WEST FALLS CHURCH ECONOMIC DEVELOPMENT PROJECT

SPECIAL EXCEPTION ENTITLEMENT APPLICATION: RESUBMISSION

CITY OF FALLS CHURCH, VIRGINIA

Comment Response Matrix

Spring Equinox (March 21)
Eastern Daylight Time

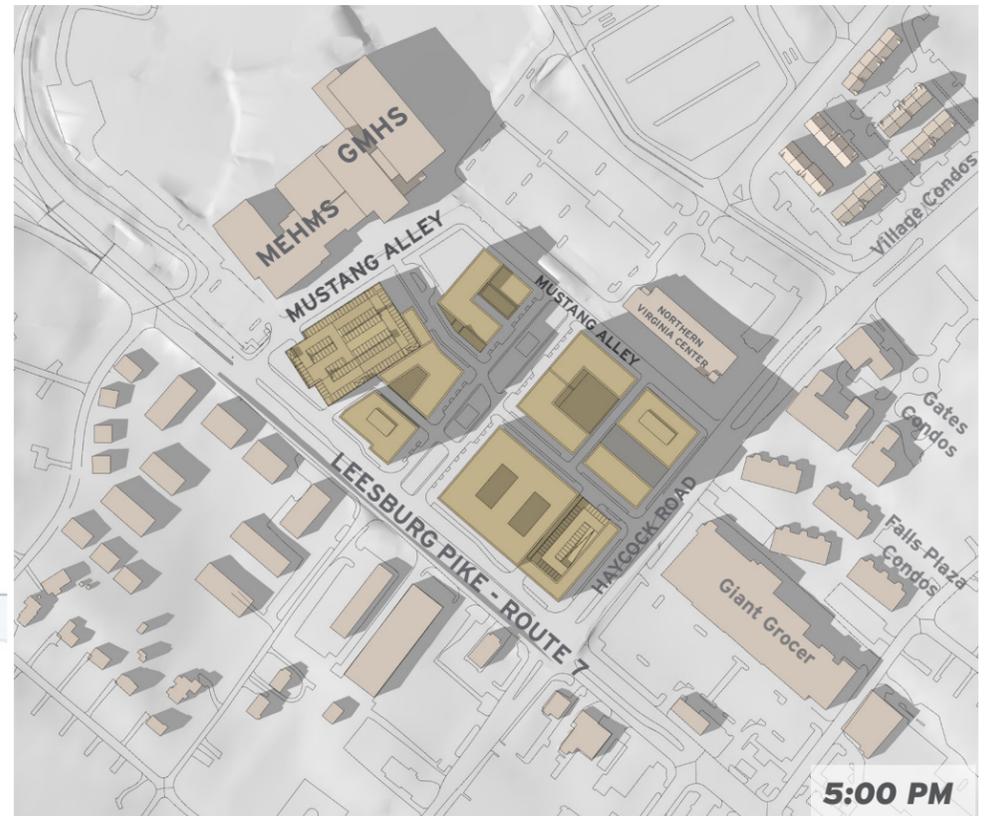
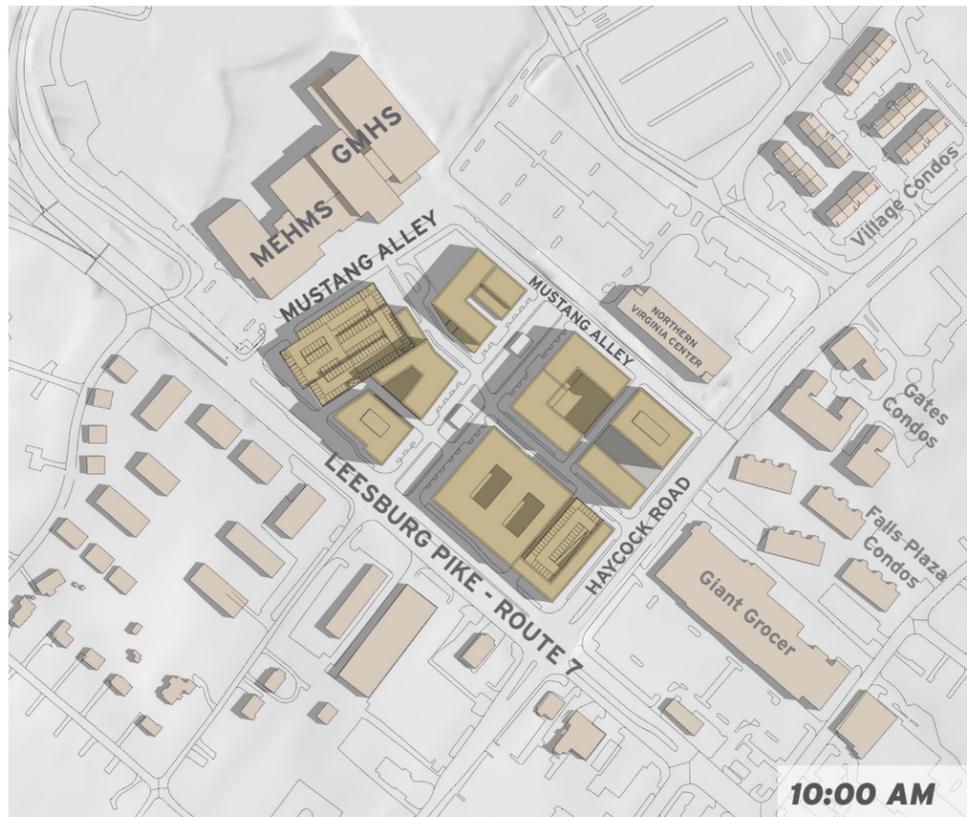
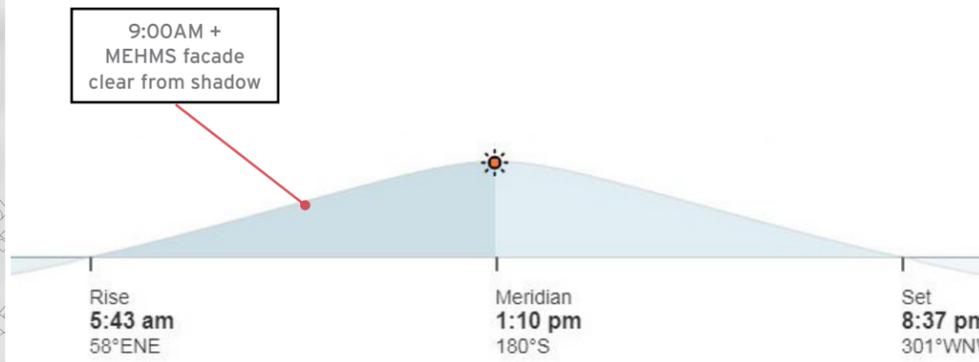
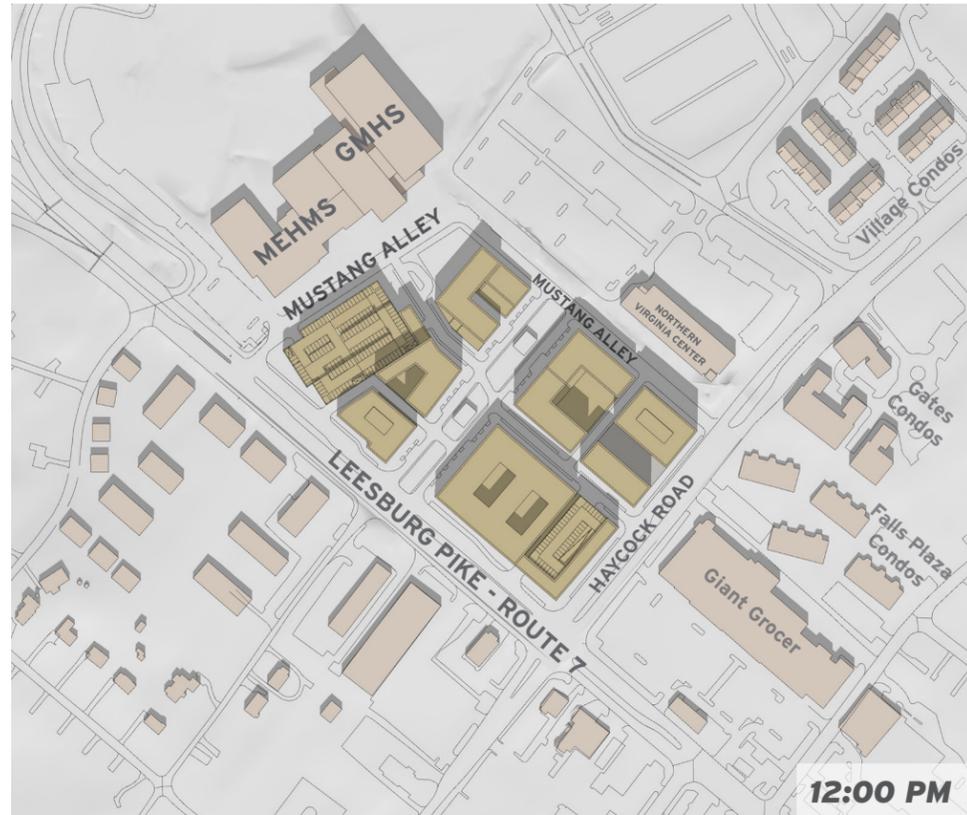
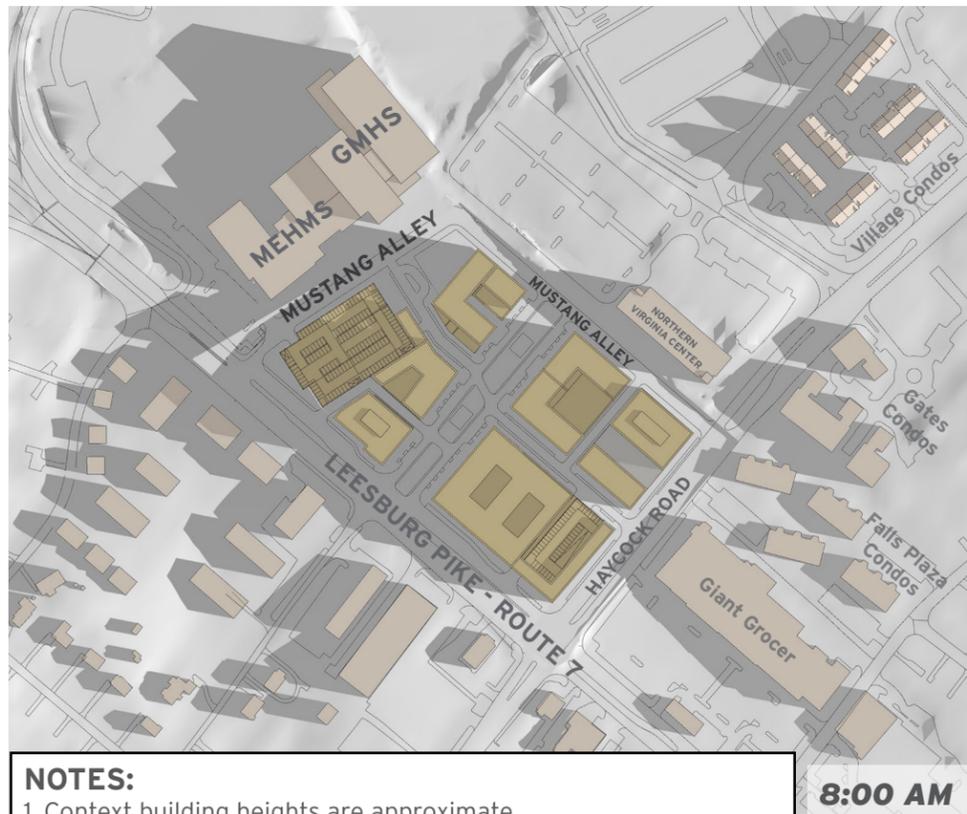
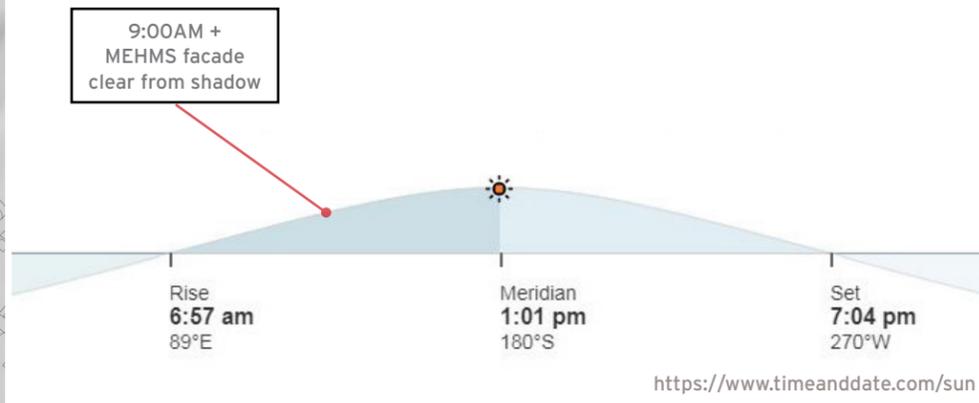
32	School Board The shadow study information included the days with the highest and lowest position of the sun. What will the impacts be at other points of the year?	The shadow study information included the winter, summer, autumnal, and vernal equinoxes at 9 AM, 12 PM, and 3 PM. Applicant has updated the shadow studies to provide information for longer periods of time - see Sheets 15-18 of the SEE design package resubmission.
33	School Board The shadow studies are based on the currently described heights. What will the impacts be if the buildings were all at the maximum allowable heights?	To the extent the buildings increase in height, shadows would get longer. Studies can be updated at SESP when building design is under consideration.
34	School Board What is the height of the parking garage and how does that compare to Mary Ellen Henderson Middle School which will be located directly across the street?	The massing diagram on Sheets 11-12 of the SEE design package resubmission provides information regarding building heights including the heights of both MEH and the parking bays of the garage. The garage height and its comparison to the middle school is located within the typical street section portion of the SEE design package. The parking garage was designed specifically to respect the height of MEH and steps back to provide vertical relief.

6	Building Height Based on the shadow study, the proposed building heights adjacent to Commons Grove Plaza will cast shadow over the plaza area all winter. Massing should be studied further to shift away from the Plaza.	Shadow studies have been updated - see Sheets 15-18 of the SEE design package resubmission - to show one option for updated hotel massing, but hotel has not yet been designed. This comment will be taken into account as hotel design begins.
7	Building Height Building Heights Diagram: Seven stories are indicated under the maximum number of stories allowed per code column. Please explain.	The 7 stories noted in this comment apply to B3, which references part of the senior housing extension. B3 references the part of the senior housing extension which was lowered in height to respect the school's desire for lowered max height approaching the school. See the updated massing diagrams on Sheets 11-12 of the SEE design package resubmission.

Proposed: Mustang Alley (Along Northern Virginia Center Parcel)

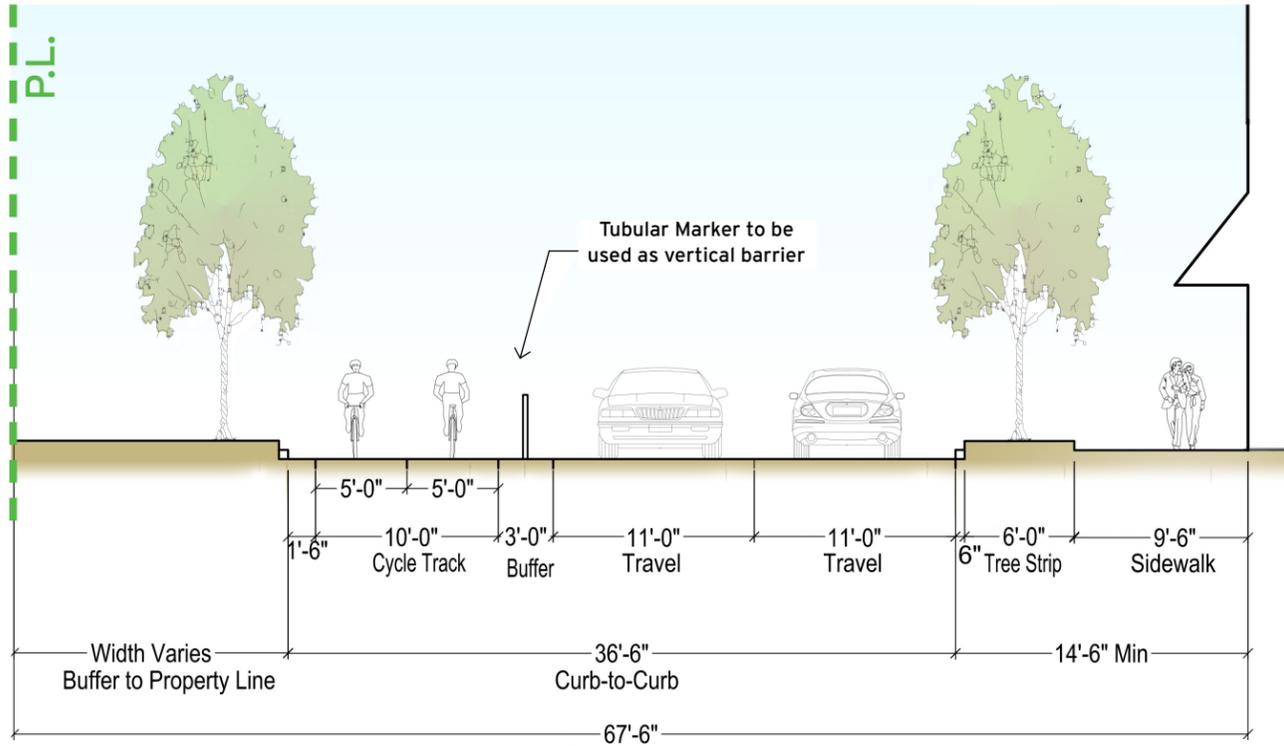
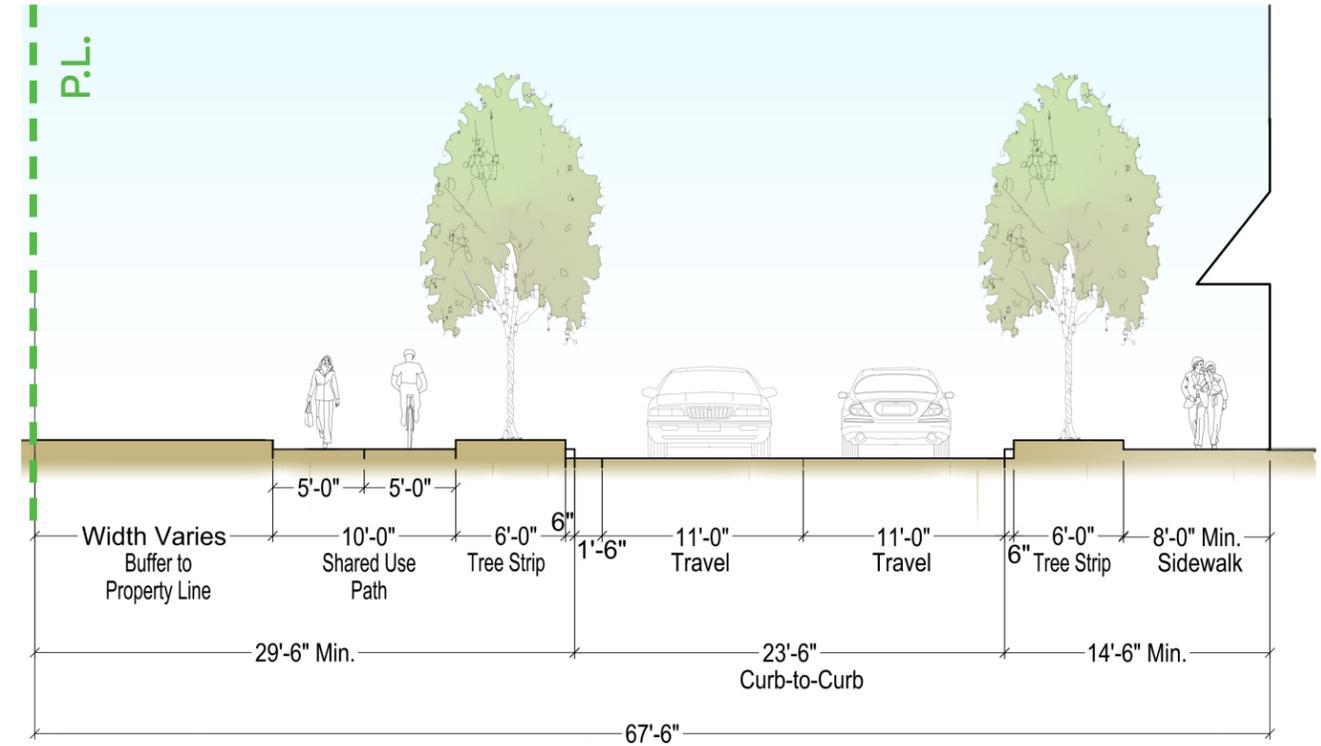
14	CACT How will access to NVC impact cycle track? Current plan makes it look as if cars will turn right through it.	Applicant is actively coordinating with the developers of the NVC site. This intersection will continue to be a main point of focus in said coordination meetings to ensure connectability and multi-modal traffic flow functions well and safely for all uses.
15	CACT Recommend installing a landscaped median to separate cycle track from traffic lanes. Bollards are not adequate or attractive for cycle track.	Applicant has designed a cycle track with bollards for cyclist safety. Per NACTO, bollards serve as both visual and physical protection for cyclists, while a curb does not provide the same height and therefore minimizes the effect of the physical separation. In addition, we are studying an alternative design that contemplates a landscape barrier and a shared use path and have included this alternate section on Sheet 22 of the SEE design package resubmission.
